**Flood Control Project Maintenance
Levee Inspections****LMA District Cover Sheet****Spring 2011 Levee Inspection Results****Tehama County Flood Control and Water Conservation District**

Waterway			Bank	Unit Miles
Unit No. 01 Deer Creek			Left	4.11

Levee Inspection Report By Mile - Spring 2011

rduffey_s_20110228_072.jpg

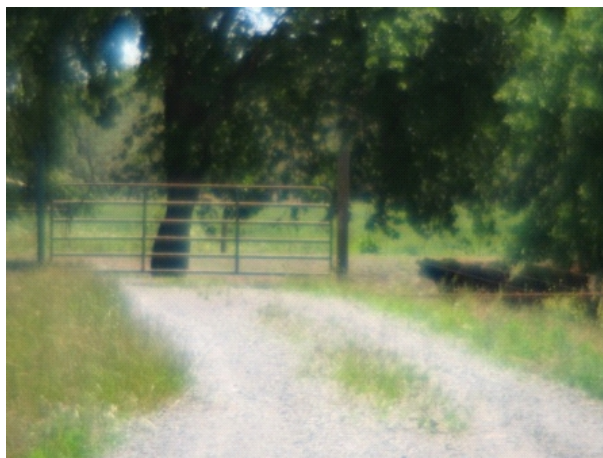
Levee Mile Report Line	8
Start Levee Mile	3.64
End Levee Mile	3.64
Location	Crown
Category	Earthen Levee
Item	Encroachments

View of the non-permitted gate on the crown of the levee.
